SHEET		1		OF		1	
MESA TOPS AT RIDGEGATE		ENTRANCE ROAD ALT A — W/O WALLS					
JOB NO.		15950.12

MESA TOPS AT RIDGEGATE
ENTRANCE ROAD ALT B
WI WALLS

PRELIMINARY ROAD REDESIGN
ALTERNATIVE 1
MESA TOPS – CABELA DRIVE
1595018
10/28/2024
SHEET 1 OF 2

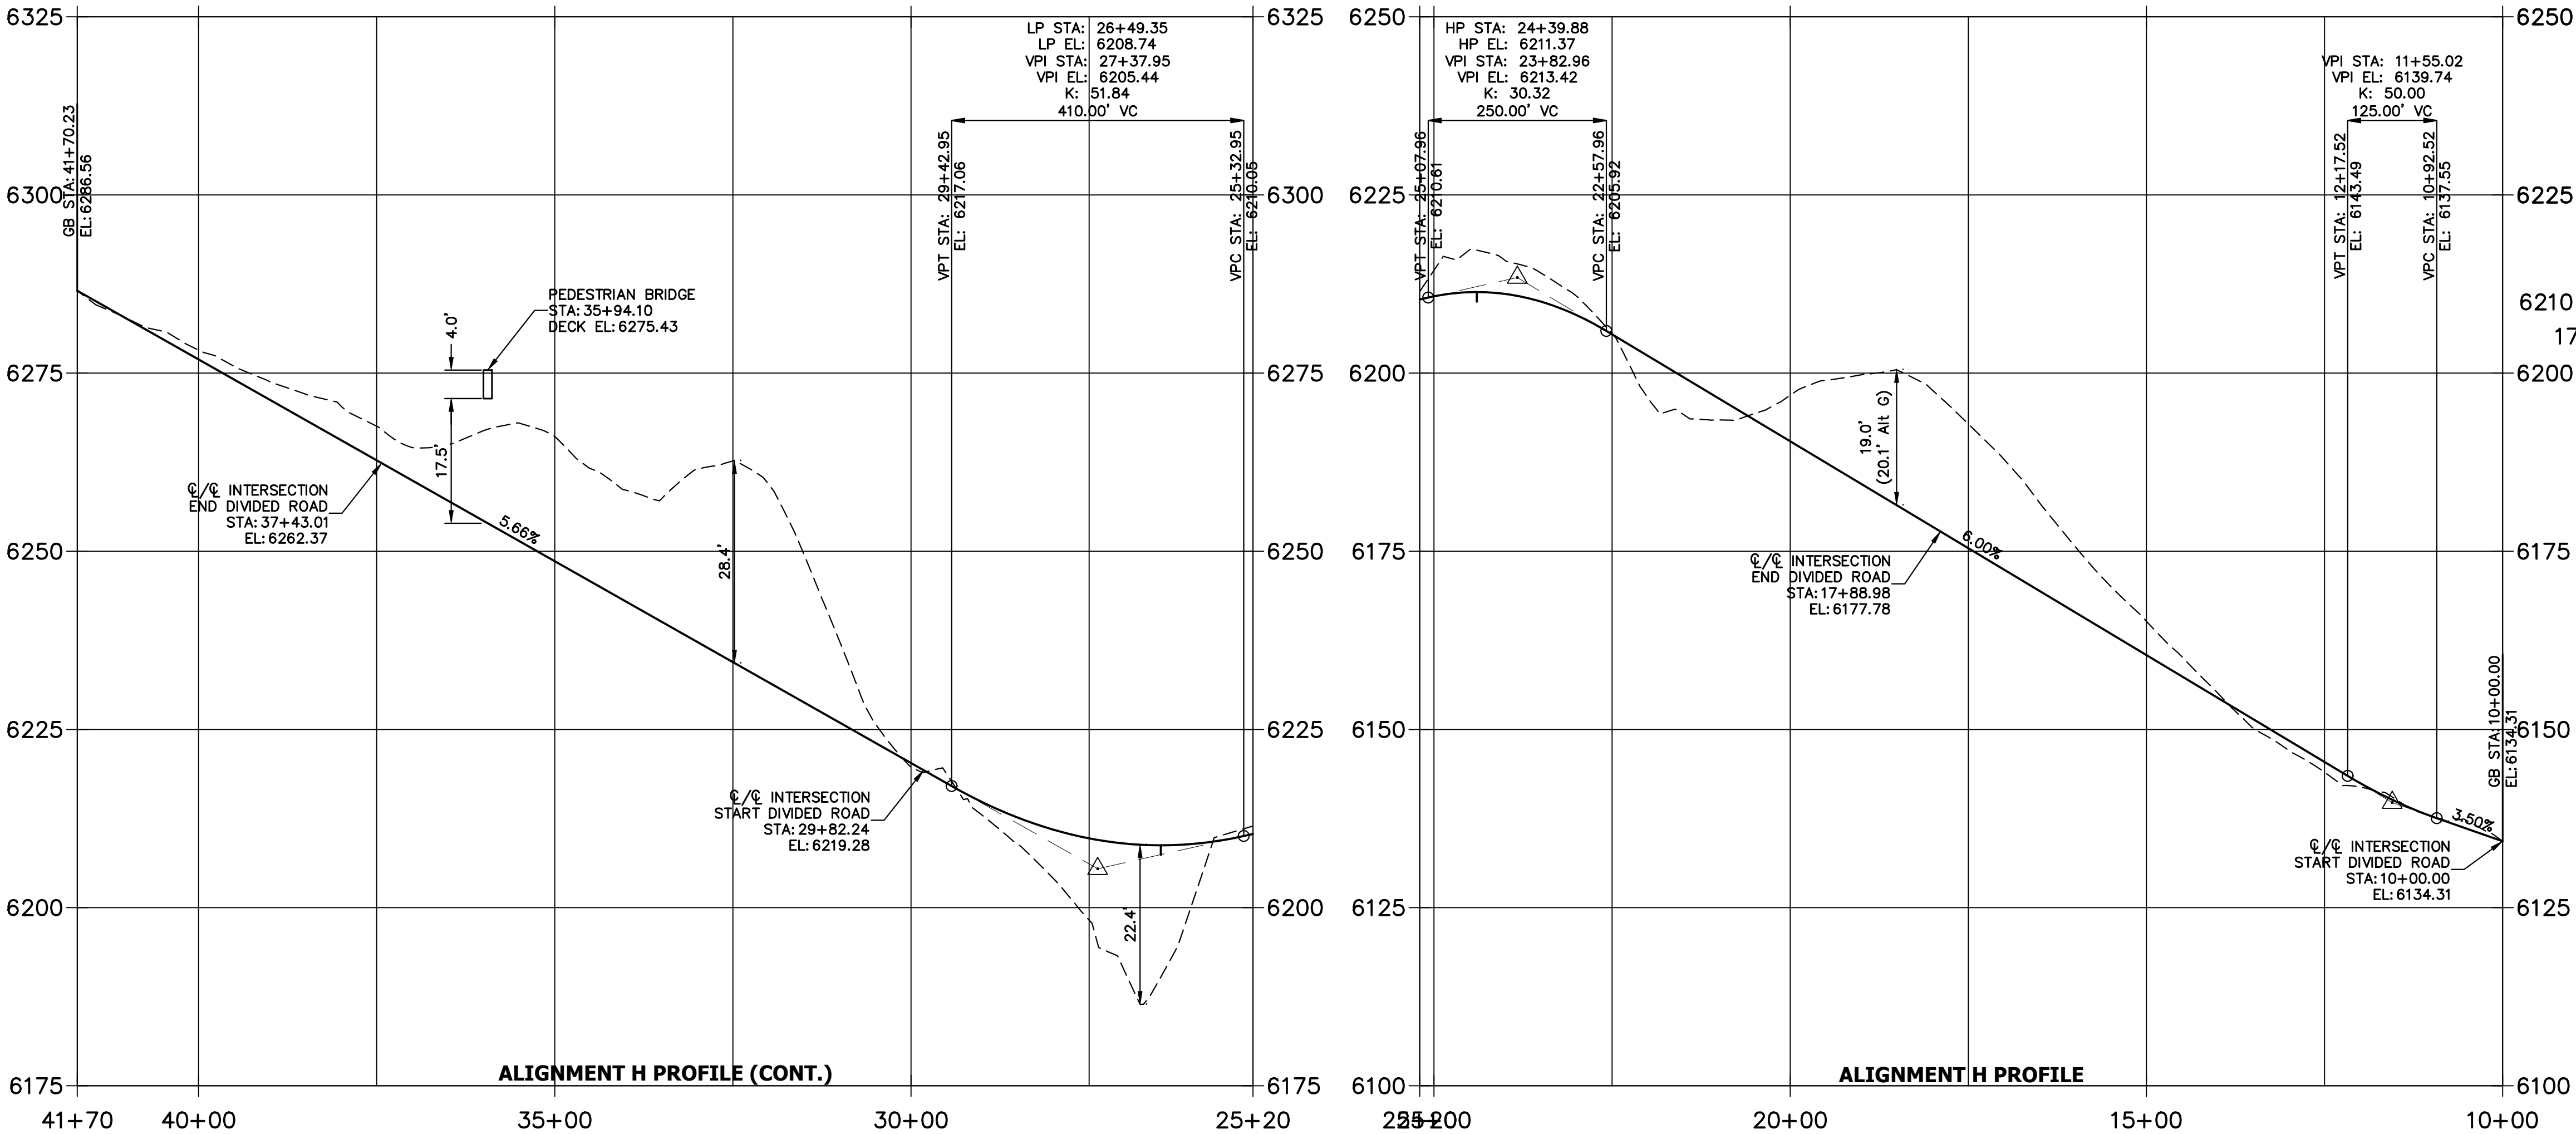
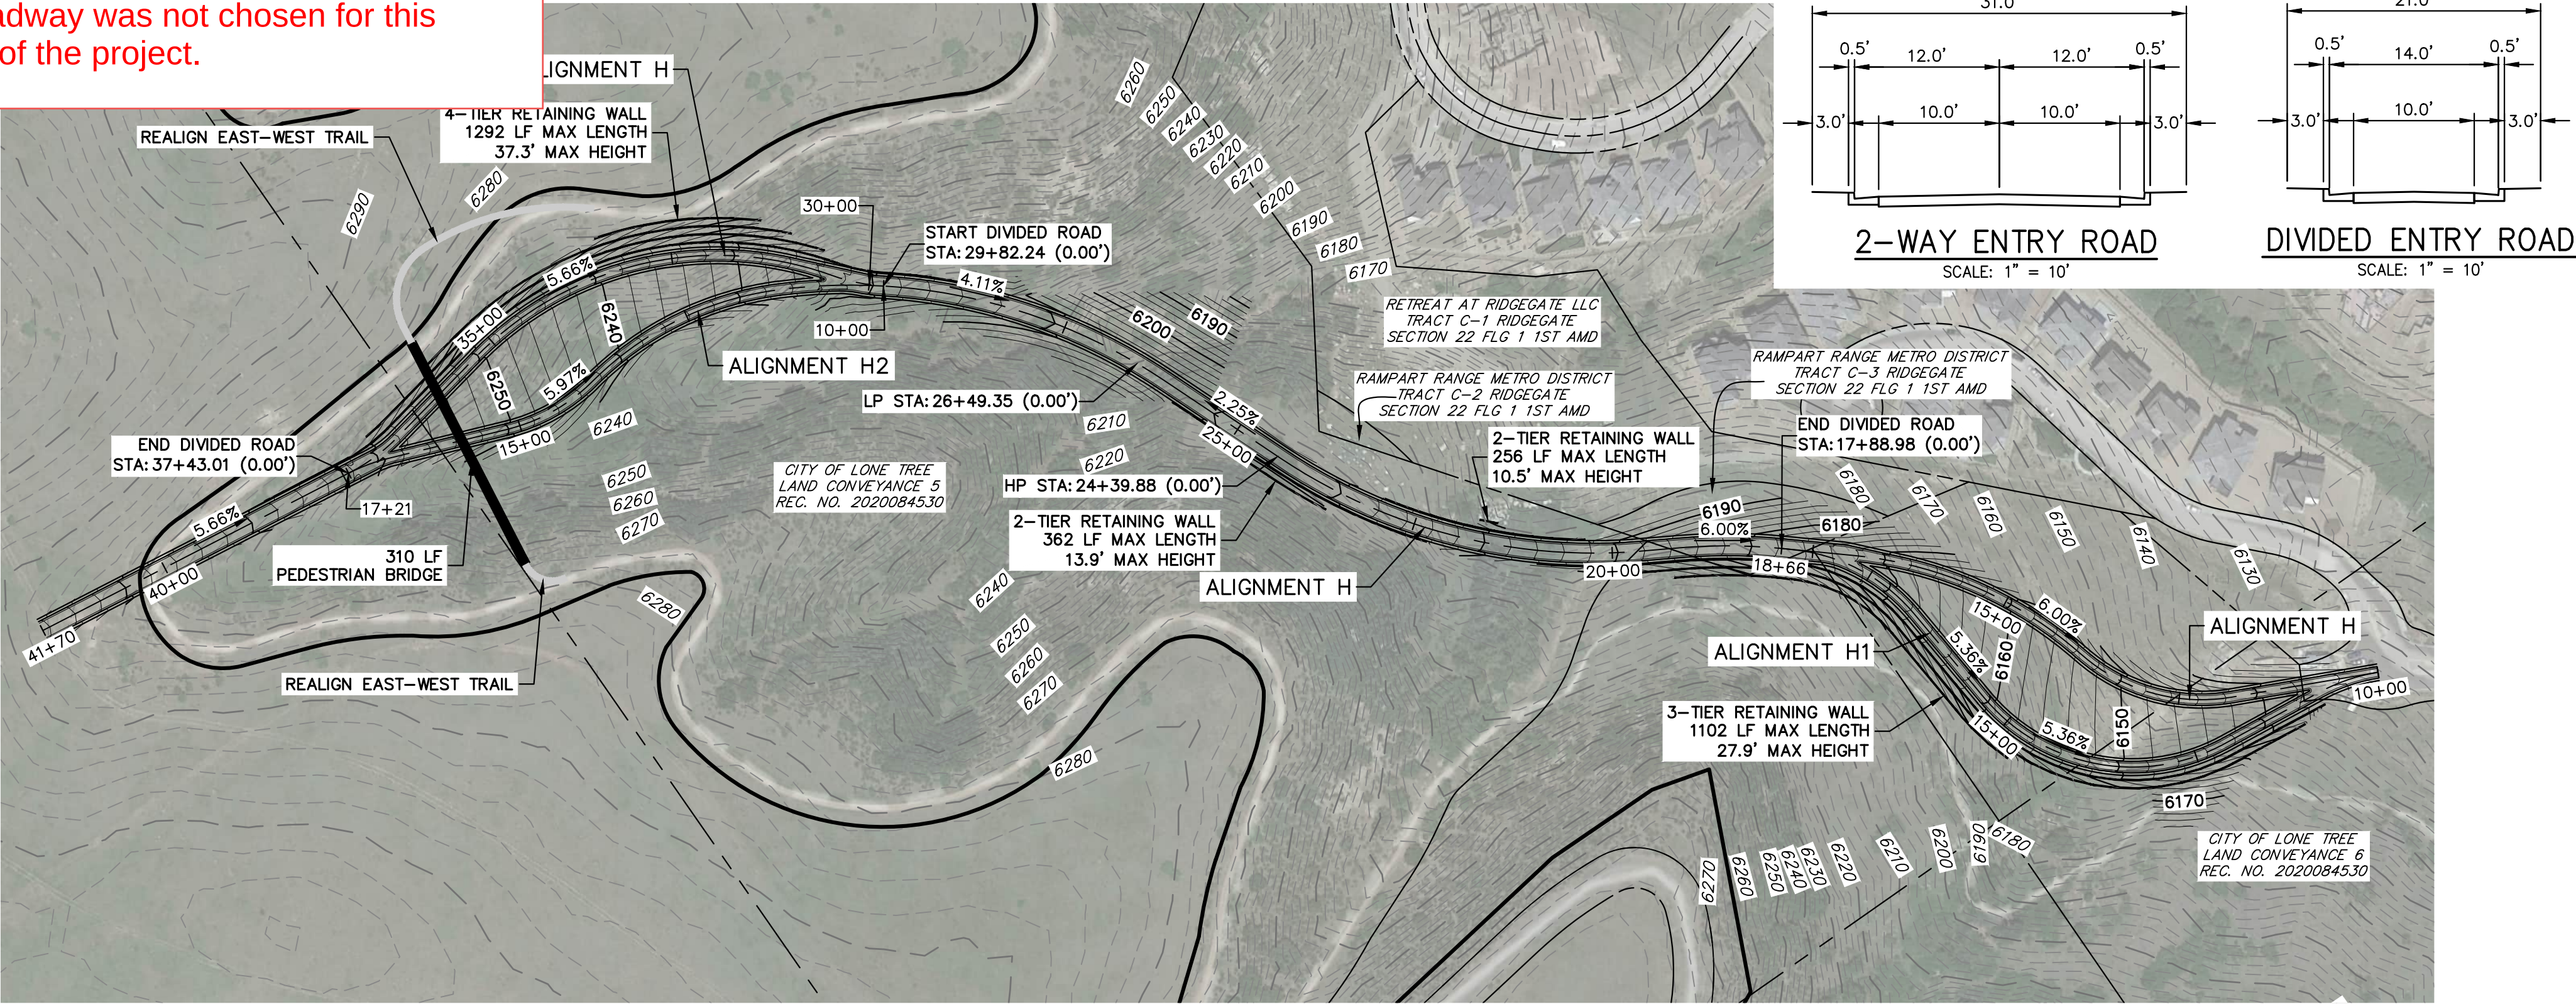
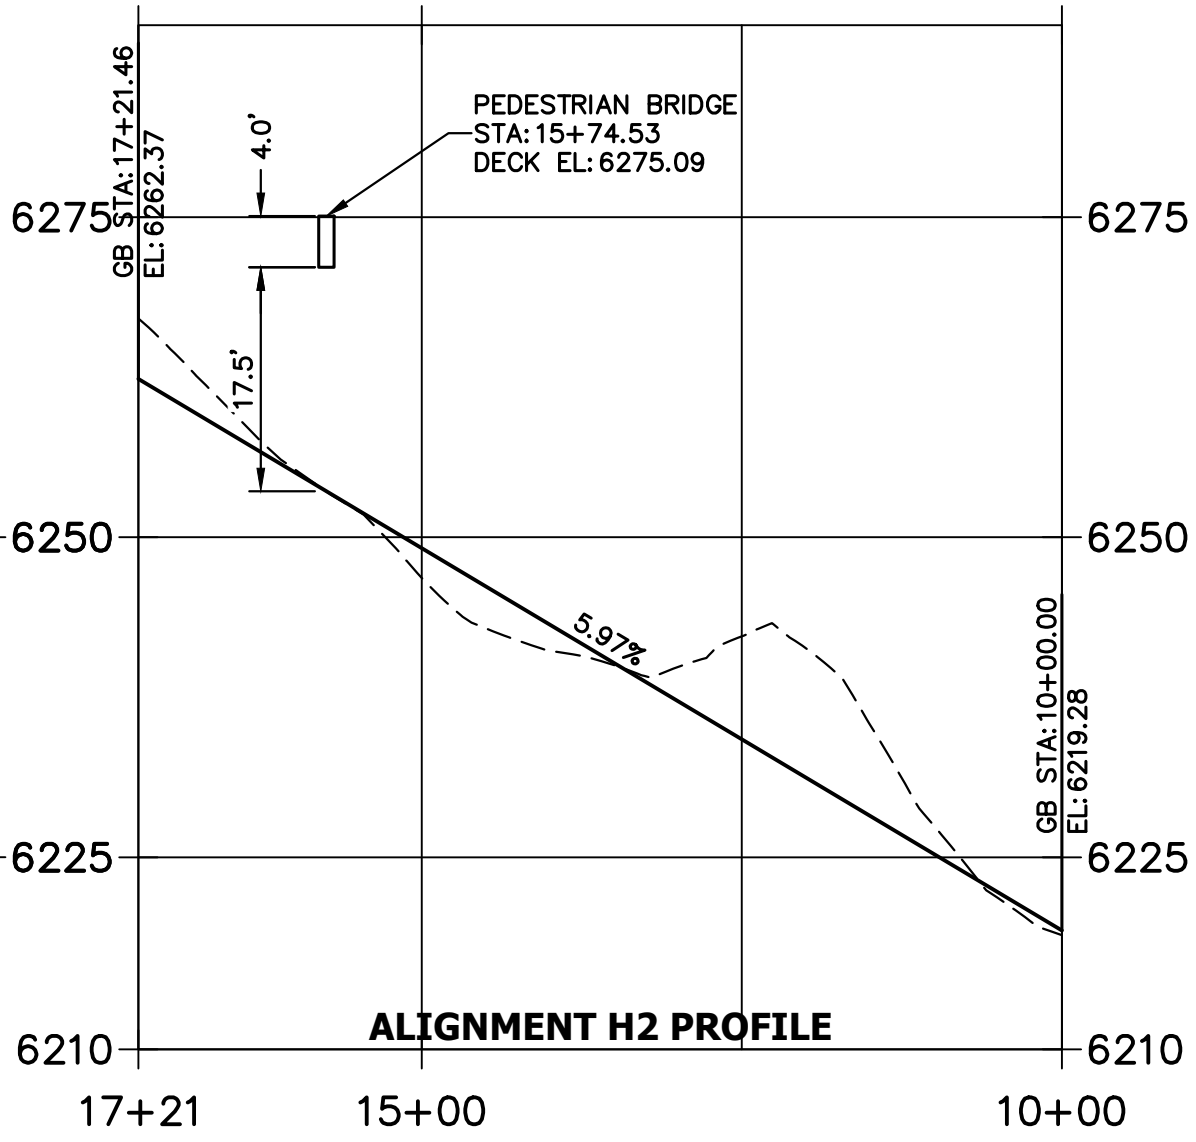
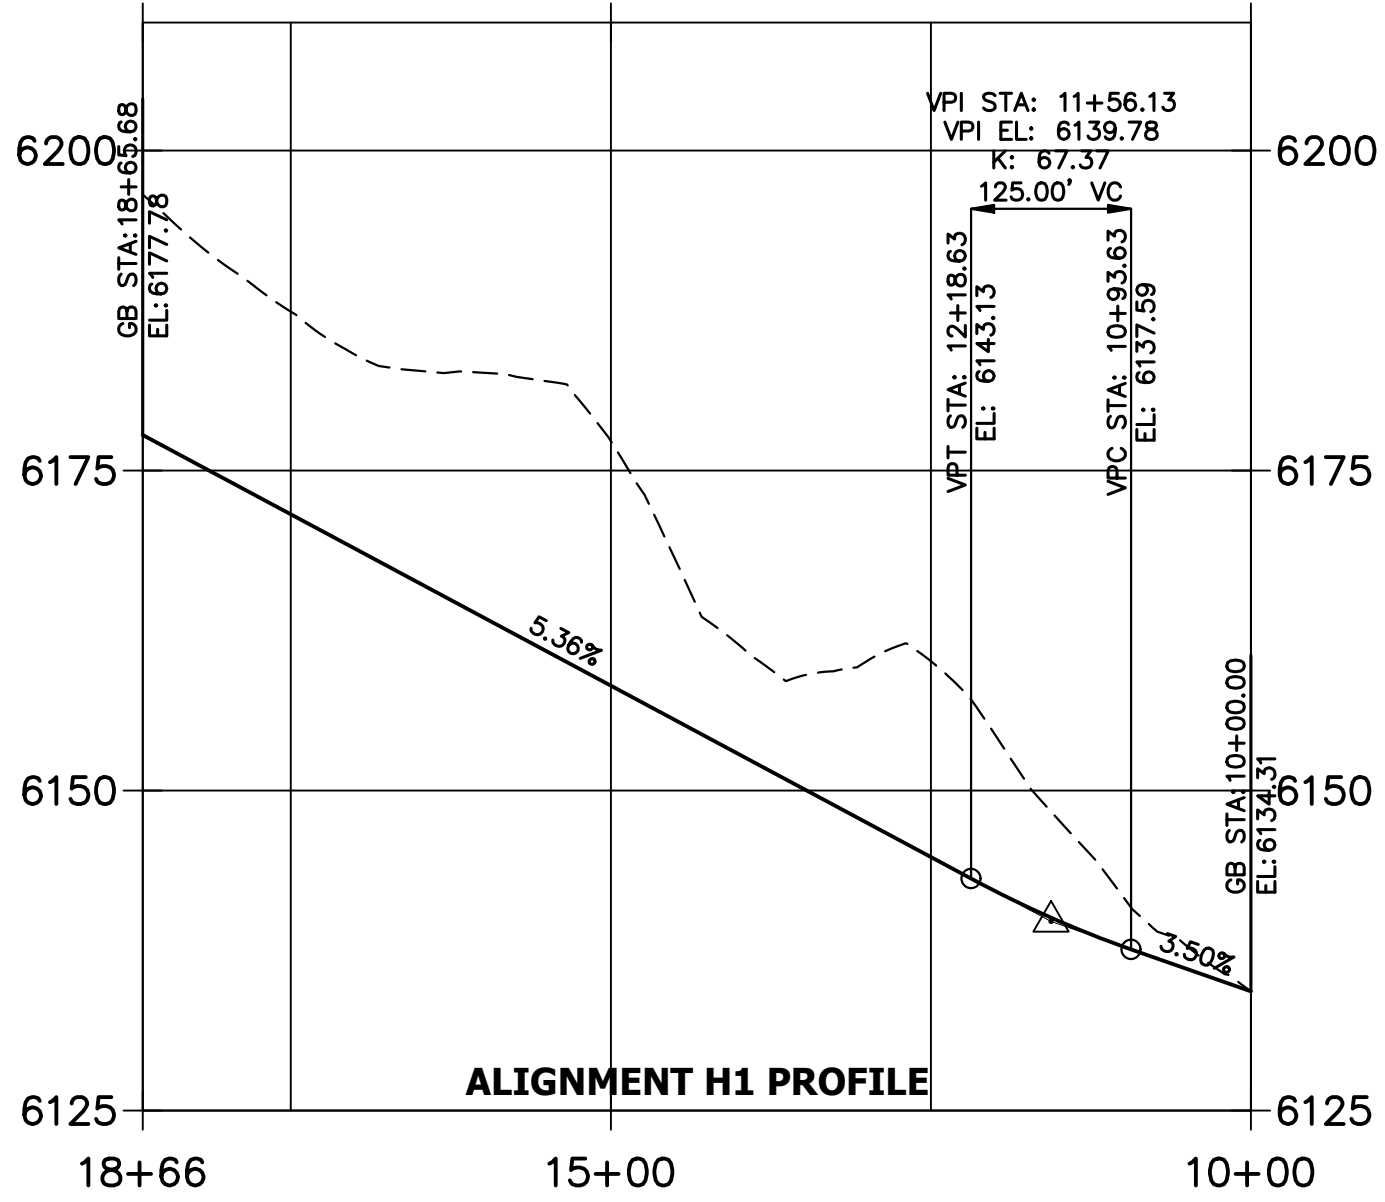
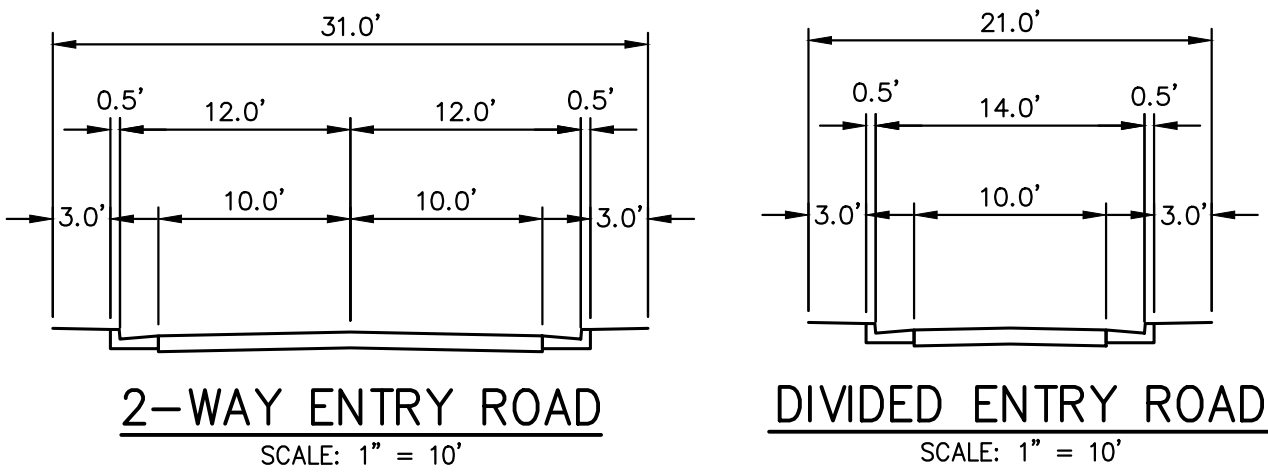
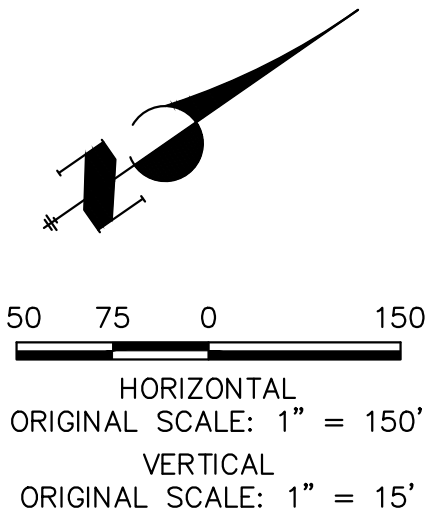
Option not selected -

- Horizontal curves do not meet collector criteria
- Split roadway was not chosen for this section of the project.
